LANDSCAPE RESPONSES FOR POMPANO SUN DRC COMMENTS

P&Z # 20-12000009

PZ20-12000009

3/3/2021

LANDSCAPE PLAN

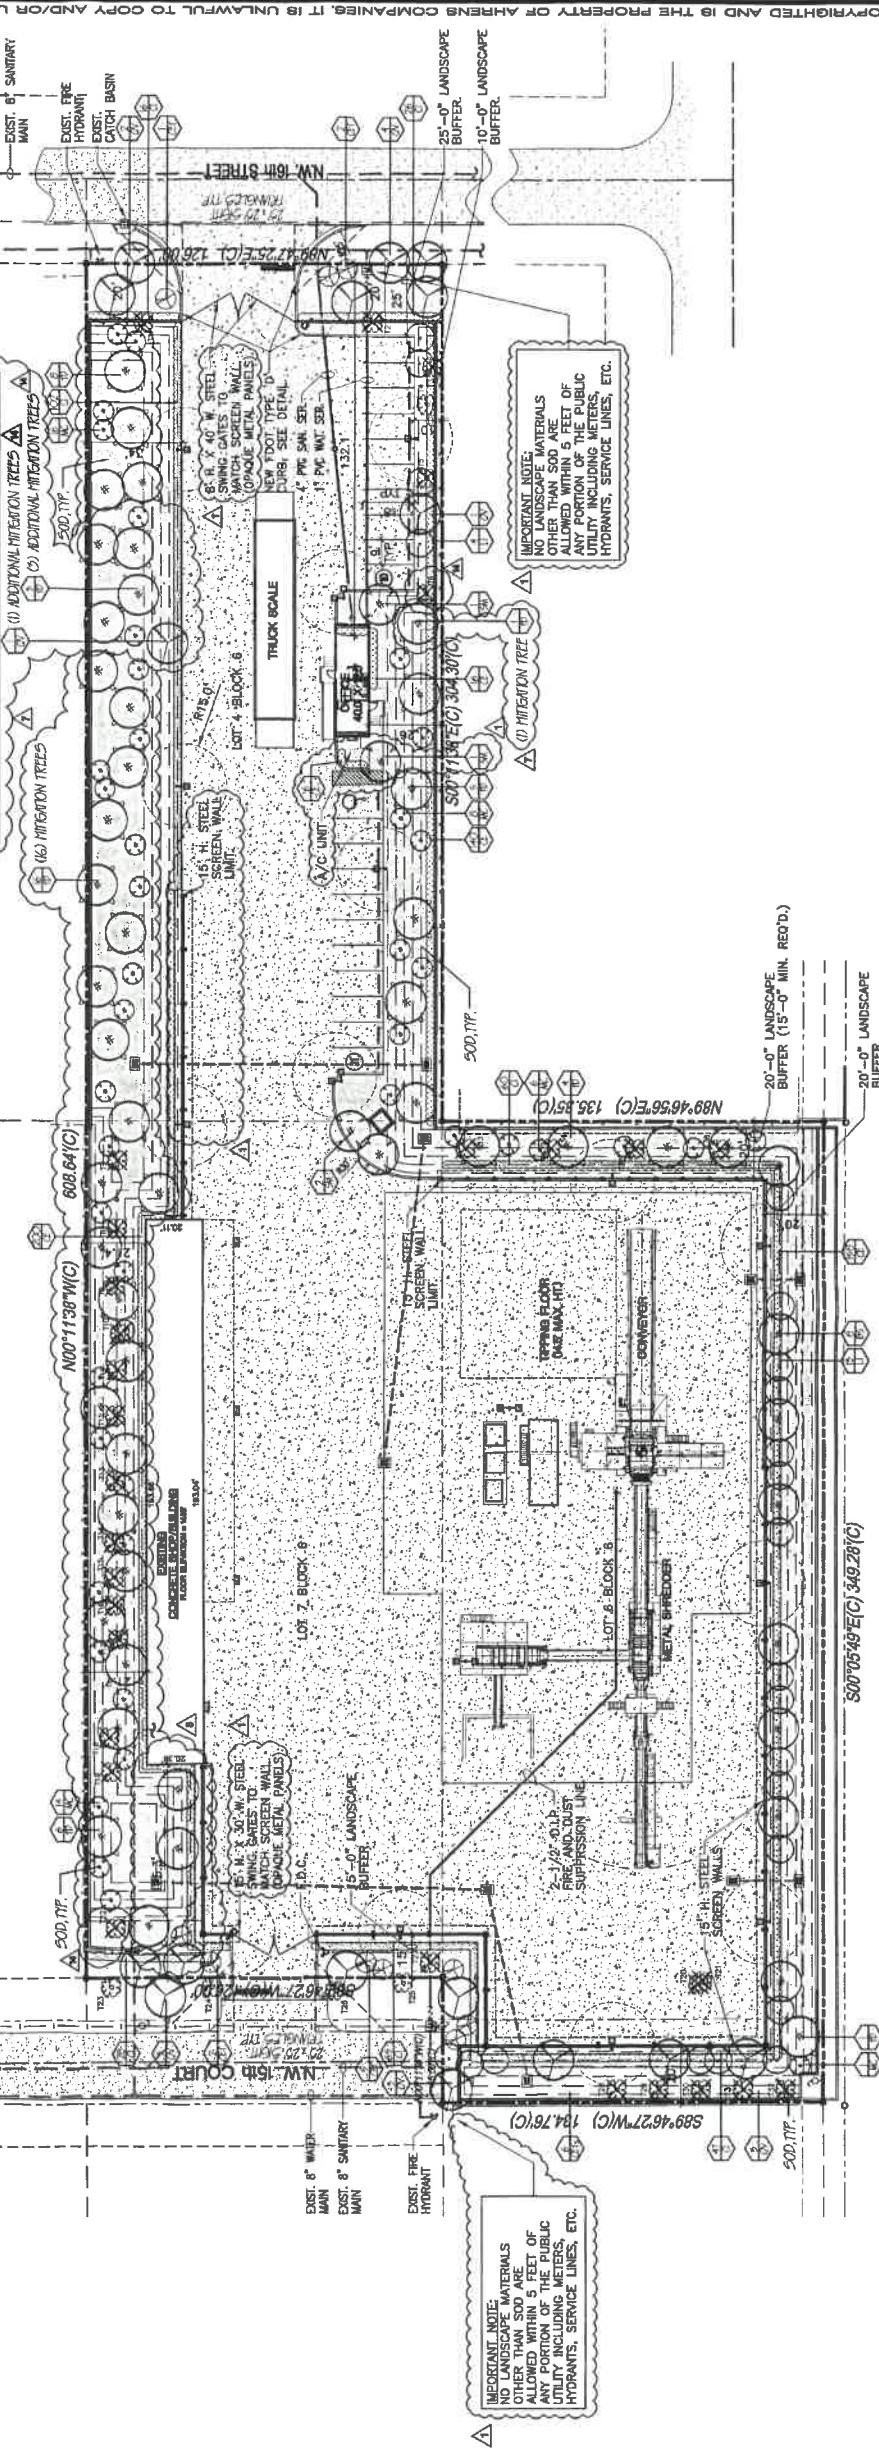
1. Please provide the previously approved plan for existing site and incorporate in the plan that addresses the property in its entirety based on the added parcel. The new plan cannot be any less than what was previously approved. Clarify on the new plan previously approved landscape and what is missing and note this on the plant list. Provide an overall, new, and previously approved table.

9. As per 155.5203.F., note the Type C buffer around the property line and label whether it's option one or option two and correct the cross-section detail. Tree count appears off.

10. No exterior lighting fixtures shall be located in any landscaped planting areas required in and around vehicular uses areas in accordance with Section 155.5401.C, Vehicular Use Area Landscaping (e.g., perimeter landscaping strips, landscaped islands in parking bays, landscaped areas between parking bays, and landscaping between vehicular use areas and buildings). Plan shows only 4 or so light poles on the plan is this correct?

18. Show retention areas on landscape plan.

Response: The Landscape Data Table has been adjusted to show the entire (both parcels); including the existing and proposed, as well as the new and previously approved quantities. Plant labels and symbology also now reflect the trees missing from the prior approved plan in 2011 and added. See Sheet LP-1 for the plan view and LP-3 for the adjusted data table

Response: The Type C buffers are labelled for all property lines; cross section details have been added to Sheet LP-1.

Response: All light poles have been added with the required perimeter setback. Existing poles have also been added with the setbacks.

Response: There are 2 retention areas. Retention Area #1 is on the east side of the site and Retention Area #2 on the west side. Both areas are labeled on LP-1.
